SERVICE BULLETIN

SERVICE BULLETIN NO: 27-020

FLIGHT CONTROLS - ELEVATOR CONTROL SYSTEM DO A CHECK OF THE TENSION ON THE STICK-PUSHER SERVO-CABLES

Replacement of the Attachment Hardware and Location of the Cable Clamps
Figure 1

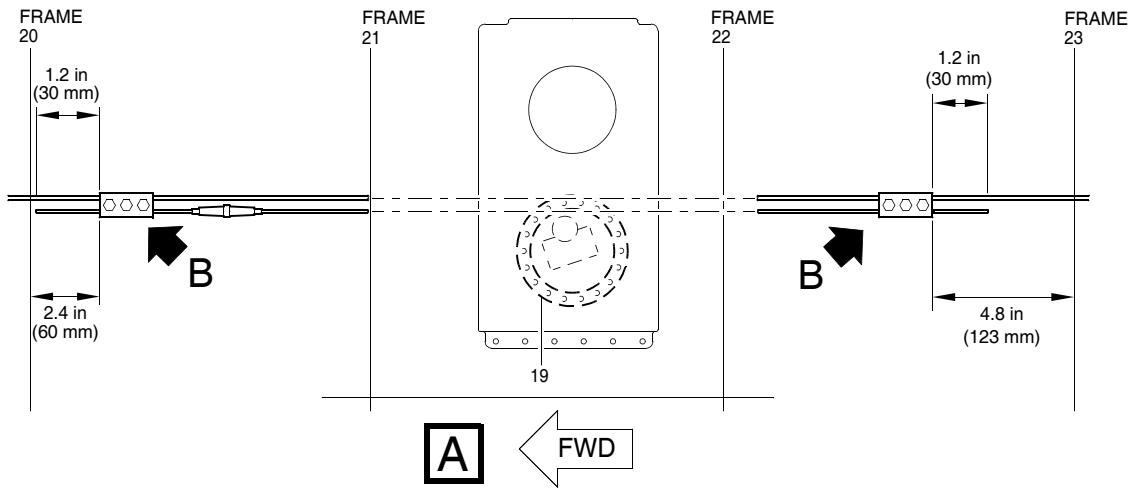
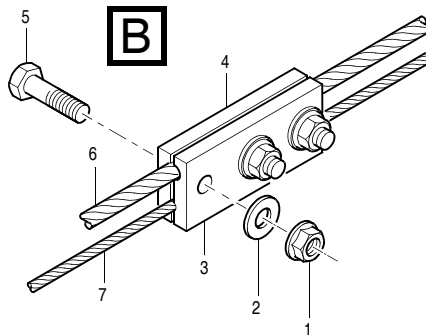
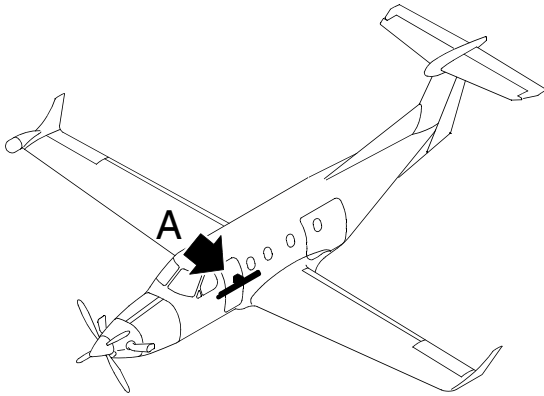
(3) If the stick-pusher servo-cables are not at the correct tension, look for signs that the cables have moved in the cable clamps (3) and (4) installed between FR20 and FR23.

(4) If there are signs that the stick-pusher servo-cables have moved in the cable clamps (3) and (4) installed between FR20 and FR23:

- (a) Remove the two locking clips from the turnbuckle that connects the two stick-pusher servo-cables. Discard the locking clips.
- (b) Loosen, but do not disconnect the turnbuckle.
- (c) Remove and discard the nuts (1), the washers (2) and the bolts (5) from the forward and aft cable clamps (3) and (4).
- (d) Remove and discard the cable clamps (3) and (4).

CAUTION: THE ELEVATOR CABLE (6) HAS A LARGER DIAMETER THAN THE STICK-PUSHER SERVO-CABLE (7) AND MUST BE INSTALLED IN THE LARGER GROOVE OF THE CLAMPS (3) AND (4).

CAUTION: MAKE SURE YOU ADD THE RUN-DOWN TORQUE OF THE NUTS (REF. AMM 12-A-20-20-01-00A-040A-A OR 12-B-20-20-01-00A-040A-A) TO THE VALUE GIVEN IN STEP 3.B.(4)(k). DO NOT APPLY ANY CORRECTION FACTORS.

- (e) Examine the cables (6) and (7) adjacent to the position where you removed the cable clamps (3) and (4) (Ref. AMM 12-A-27-00-00-00A-313A-A or 12-B-27-00-00-00A-313A-A). Replace as necessary.
- (f) Get new cable clamps (3) and (4), as necessary, and new nuts (1), washers (2) and bolts (5).

- (g) Put the clamps (3) and (4) in position on the elevator cable (6) and the stick-pusher servo-cable (7).
- (h) Apply grease (Material No. P04-029) to the threads of the bolts (5) and the nuts (1) and loosely install all six bolts (5), washers (2) and nuts (1).
- (i) Make sure the stick-pusher servo-cable is correctly installed on the capstan (Ref. AMM 12-A-22-20-06-00A-920A-A or 12-B-22-20-06-00A-920A-A).
- (j) Make sure the clamps (3) and (4) are in correct position and tighten the nuts (1).

- (k) Torque the nuts to between 4 and 4,5 Nm (35 and 40 lb in.).
